Re: Normandy Heights Plat Wetland and Fish and Wildlife Habitat Assessment Report—Third Party Review

Confluence Environmental Company (Confluence) has reviewed the wetland and fish and wildlife habitat assessment report (the critical areas study report) submitted by Soundview Consultants (Soundview) for the Normandy Heights Plat project (PLPMP20220090) located at 2007 Shaw Road, Puyallup Washington (Parcel 0420354039) (Soundview 2022).

Figure 1. Location of CEC-1 and possible wetland area

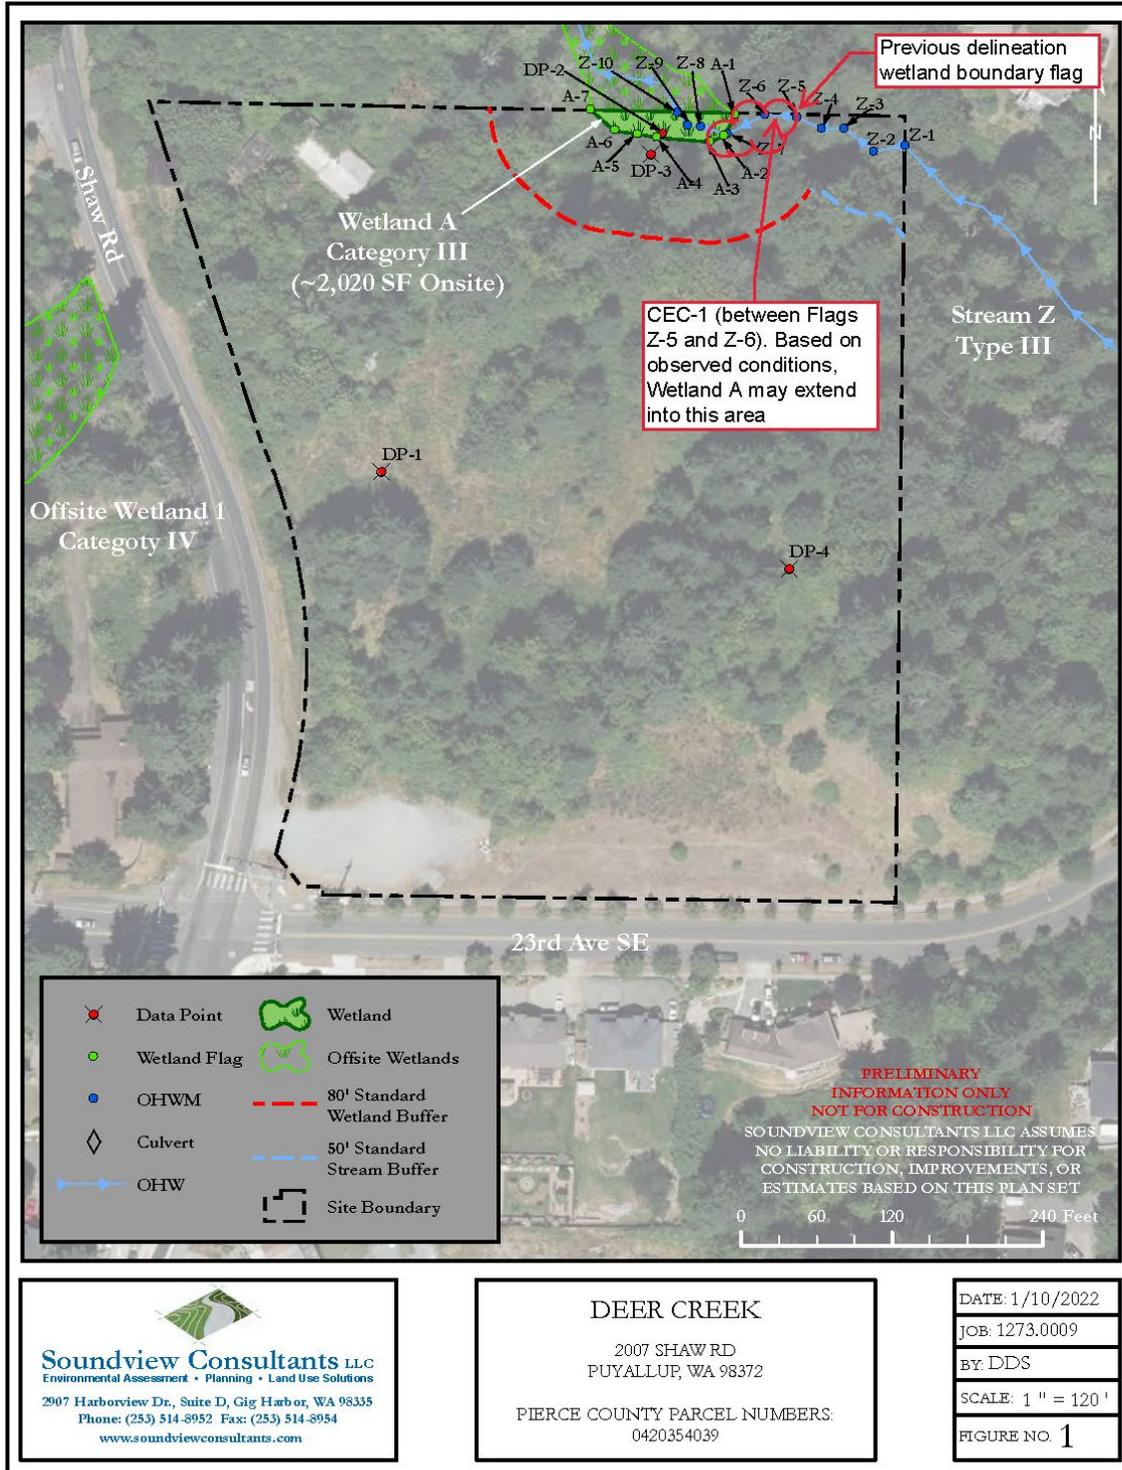
During our field investigation, we observed wetland characteristics east of the delineation boundary flags A-1 and A-2. Additionally, we found an old wetland delineation boundary flag attached to the northeastern site boundary fence line at Flag Z-5. The flag was not labeled with a date or company name. Confluence dug a soil probe labeled CEC-1 on the south side of the stream between Z-5 and Z-6 (Figure 1). Confluence observed several plant species of facultative (FAC) and obligate (OBL) listings, including the following: skunk cabbage (*Symplocarpus foetidus*) (OBL), piggy-back plant (*Tolmiea menziesii*) (FAC), water-parsley (*Oenanthe sarmentosa*) (OBL), salmonberry (*Rubus spectabilis*) (FAC), and lady fern (*Athyrium filix-femina*) (FAC). Presence of these species meets the hydrophytic vegetation criterion. Saturated soils were observed at 9-10 inches below ground surface, with groundwater coming into the test pit at 10 inches, thus meeting the wetland hydrology criterion. Soil in the top layer (0-11 inches) was as 10YR 2/1 silt loam.

Confluence did not dig past 11 inches, but assumed that A11—Depleted Below Dark Surface or A12—Thick Dark Surface are possible given the 10YR 2/1 soil color and depth. Otherwise Confluence agrees with the wetland boundary between Flags A-2 through A-7 and the approximated off-site boundary.

Because the stream centerline was flagged and not the OHWM, it is also unclear in the report if the stream buffer shown in Figure 1 is a 50-foot buffer from the stream centerline (which what was flagged and presumably surveyed) or a 50-foot buffer from an assumed 2-foot OHWM. Please clarify if the buffer is from the centerline or an assumed 2-foot OHWM. Photos of the stream channel with pin flags marking the OHWM would be helpful and may result in Confluence not having to conduct a second site visit to confirm the OHWM delineation.

- Reassess and revise the delineation of Wetland A to include the wetland area to the northeast of the stream and update the field-flagging to extend to the site boundary and wetland boundary flag attached to the fence. Update the report and appendices C, D, and E accordingly.
- Update the Appendix F – wetland rating form sections H1.1 H1.2 and H1.4 for Wetland A as described above. Please note that this may also result in an increase in wetland buffer widths.
- Update the report to provide data on OHWM widths and clarify if the buffer was measured from the centerline or the OHWM. Please include photos showing the OHWM.
- Update the report and change the stream typing from Type III to Type II.
- Update site plans to depict changes in wetland size, wetland category, stream type, and associated buffers.

DEER CREEK - HABITAT MAP

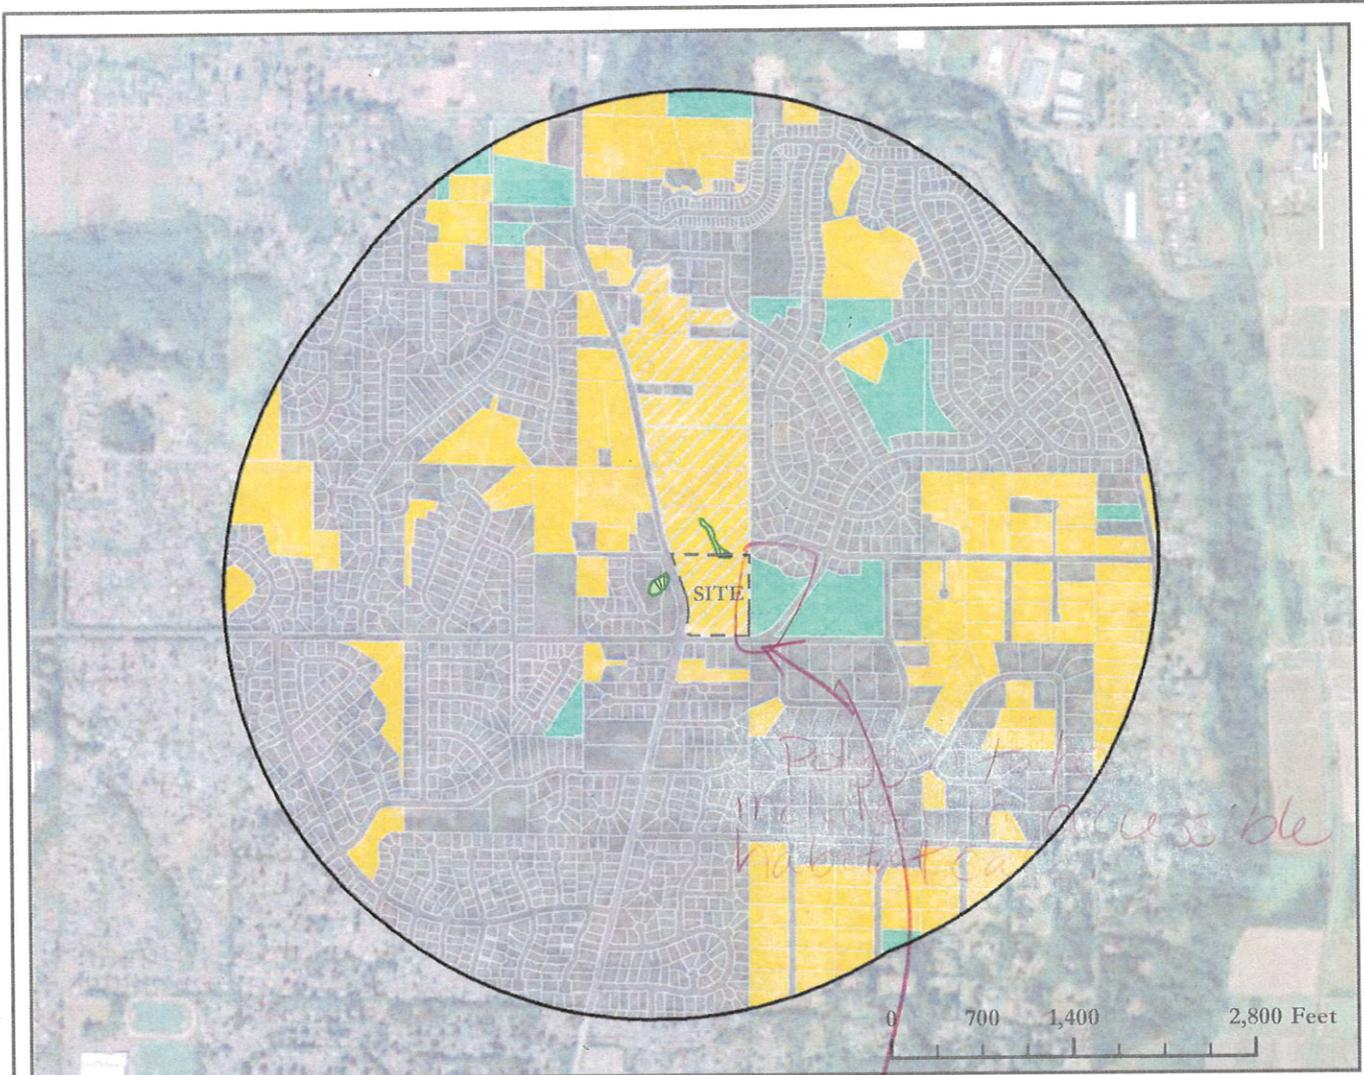
Handwritten note: polygon should be included in accessible habitat calc. because there is no human disturbance between polygon + wetland
